To: Oshawa Active Transportation Advisory Committee  
From Projects Working Group 2023 08 21  
Subject: Wentworth Street Reconstruction: Cedar Street to Farewell Street.

**1. Purpose:**

To provide comments regarding transportation on the proposed reconstruction of Wentworth Street by the Region.

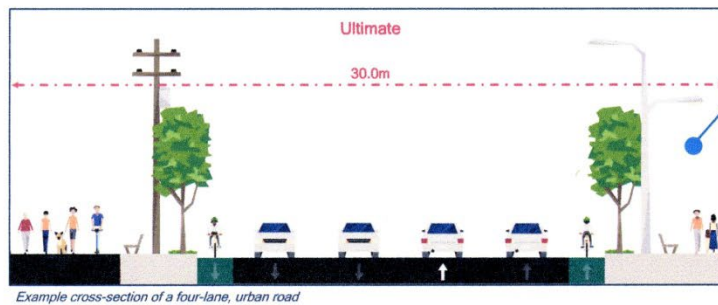
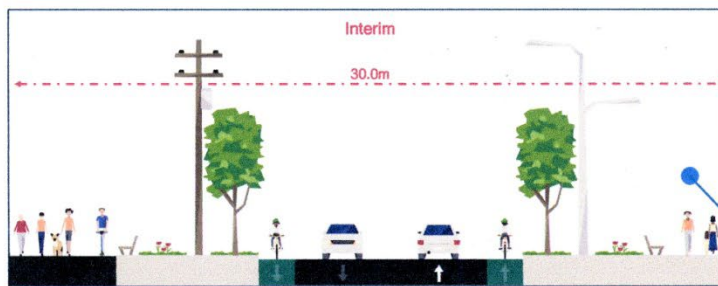
- 4.2 To provide a balanced road system cycle lanes or protected cycle lanes are required as well as the multi-use path on Type “C” arterial road with direct driveway access. A boulevard multi-use path provides beginners going to school or neighbours, for family outings with a safe facility as their speed does not insurmountably conflict with cars backing out of driveways waiting for a break in traffic and watching between the curb only. However experienced cyclists and e-scooters users going quickly to work or other functions would not be seen by drivers as they stop across the multiuse path to observe traffic between the curbs. For a balanced transportation system both facilities are required as shown on the City drawings for Stevenson Road N. Attachment No. 1 (From City of Oshawa Stevenson Road N. EA.)
